Report

To	Scott Paterson - QLDC	Contact no.	-
Copy to	-	Email	lan.Ho@ghd.com
From	Anthony Kirk, Ian Ho	Project no.	12645246
Project name	Shotover WWTP Disposal Field Alternative Discharge		
Subject	Shotover WWTP long term wastewater disposal - 30% design amendments

Figure 2 *Predicted dispersions of effluent when discharged at the river edge.*

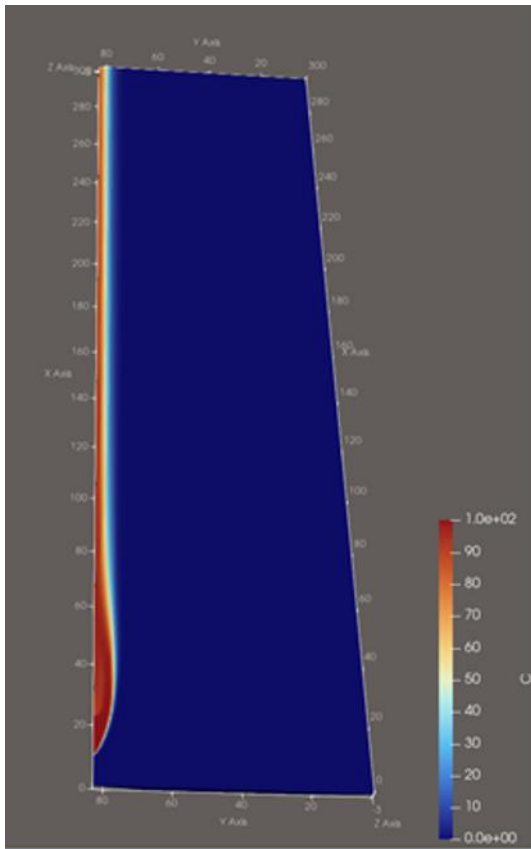
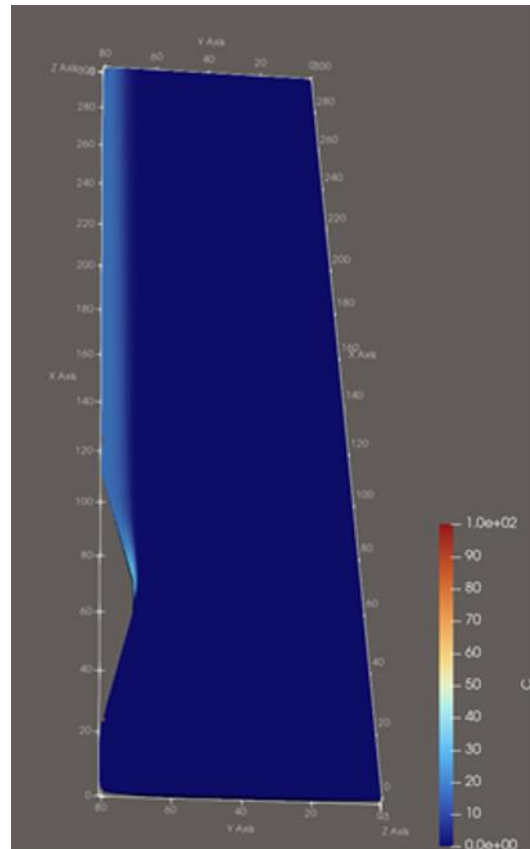
Modelling of the initial Option A discharge, where treated wastewater would discharge at the river edge through a rock-filled channel, predicted that the treated wastewater would be effectively trapped along the riverbank, with minimal dilution occurring. In practical terms, this meant that concentrations of nutrients and residual pathogens close to the riverbank would remain elevated over a significant distance downstream. The key findings of the initial water quality assessment were:

Figure 2 illustrates the predicted dispersion of treated wastewater when discharged at the river edge, as with the initial rock channel concept design (colours reflect the percentage of treated wastewater concentration). Figure 3

illustrates the predicted dispersion when the effluent is discharged 10 m out from the bank, showing improved mixing.

Where the original river-edge design was predicted to achieve minimal dilution at the riverbank, the amended design achieves an immediate approximately 3-fold dilution at the point of discharge, and a total of approximately 5-fold dilution within 40 metres downstream of the structure. While the discharge structure and shallow, slow, flowing waters adjacent to the riverbank are still predicted to limit dispersion prior to the Shotover River confluence, the residual concentrations of nutrients and pathogens in this zone are predicted to be significantly lower than for the initial Option A design. This is important because it reduces concentrations of nutrients, and so

Figure 4 Option A outfall arrangement

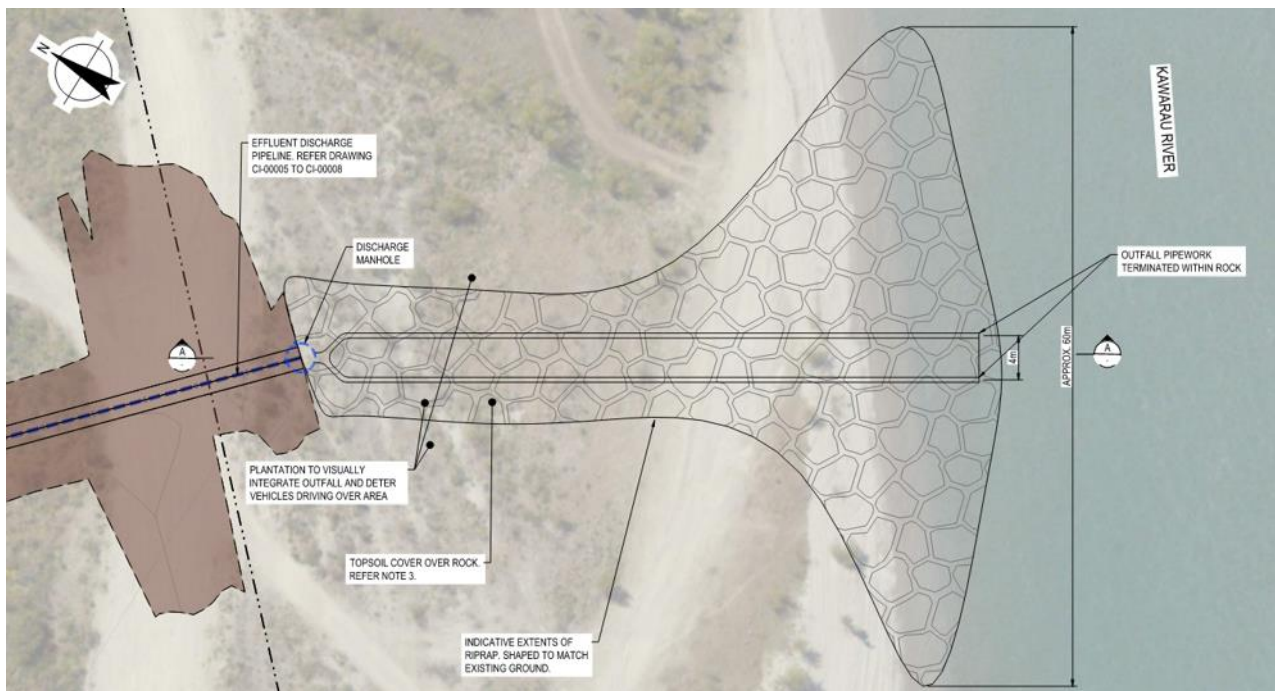
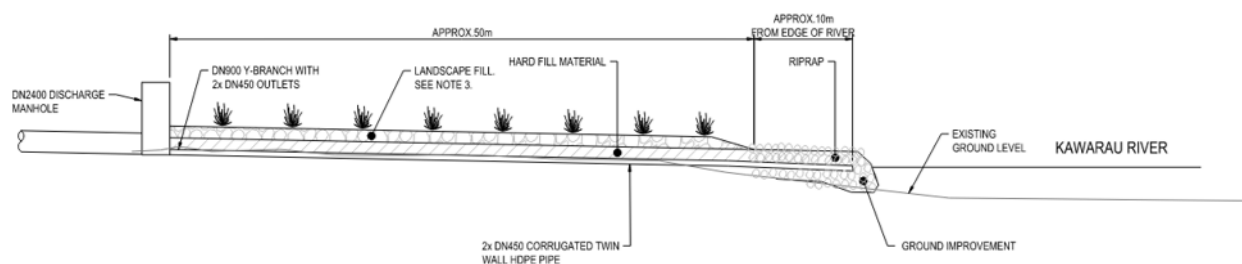
The initial Option A outfall arrangement allowed for treated wastewater to flow through placed rocks and discharge at the river edge. When water levels increased, the zone of discharge and mixing would follow the river edge up the riverbank. In responding to the need for improved dispersion and dilution of treated wastewater, the discharge structure was amended to no longer discharge at the river edge, and instead convey the wastewater so that the point of discharge is approximately 10 metres into the river where the deeper and faster-flowing part of the channel begins. The amended design is illustrated in Figure 4 and Figure 5.

- **Extended discharge point:** The outfall structure extends approximately 10 metres into the Kowarau River, with the base of the structure set approximately 1 metre below low river level. This positions the discharge at the boundary between the shallow margin and the faster main channel, ensuring that treated wastewater enters the river where current speeds are sufficient to promote rapid mixing.
- **Piped conveyance:** Treated wastewater is channelled to the end of the structure through pipes, rather than flowing loosely through placed rocks. This ensures that mixing occurs in faster-flowing water rather than seeping out along the river edge.

- **Rock armouring and erosion protection:** The conveyance pipe is covered with an approximately 10-metre-wide riprap cover to protect against erosion and to discourage public access to the outfall area.
- **Tapered rock form:** The rock structure tapers back into the riverbank, reducing the formation of back-eddies behind the structure that could otherwise trap discharged treated wastewater. The blending of the structure with the riverbank is also intended to reduce the visual impact of the structure.
- **Landscaping and planting:** Additional rockwork and planting around the outfall to help the structure blend into the surrounding delta landscape and further discourage direct public access.

Figure 6 *Engineer filled area, located at bottom of Pond 3a, indicated in the yellow fill*

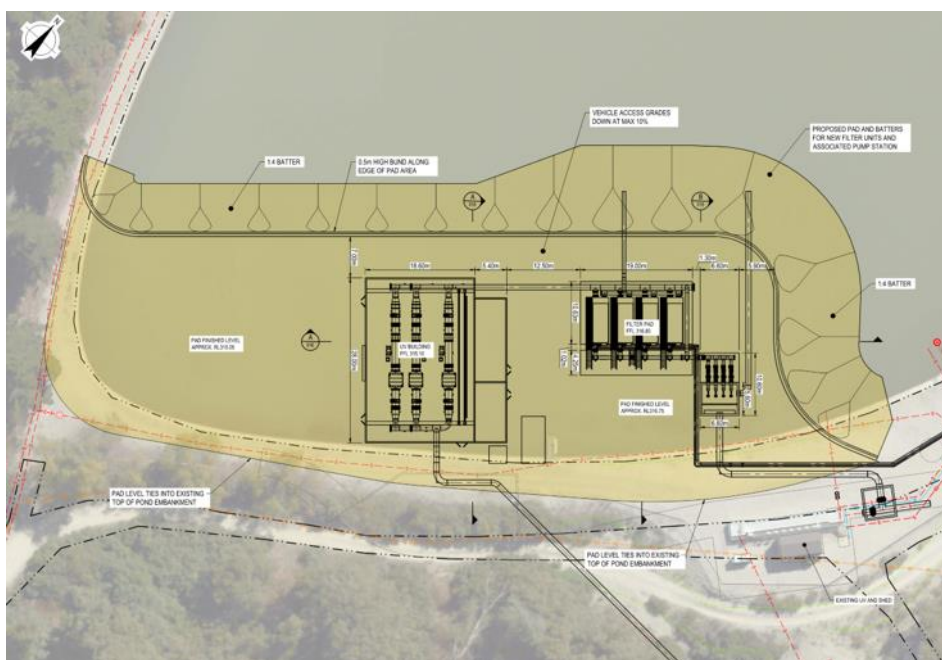
The existing UV system capacity was assessed in the context of virus removal and found that it was unlikely to provide the required additional disinfection. Upgrading the existing unit in place is not practical, as it would require the system going offline for an extended period, and so the amended design allows for replacement of the existing unit with a new, larger, enhanced UV system, sized to deliver the higher virus-removal performance across the full range of expected future flow and water clarity conditions, with redundancy built in. The new system would be located in a new building constructed on an engineered fill platform within Pond 3, which also accommodates the tertiary filters, a new transformer and a backup generator, and includes provision for future expansion.

Figure 6 provides an outline of the platform in Pond 3 and the refined treatment infrastructure.
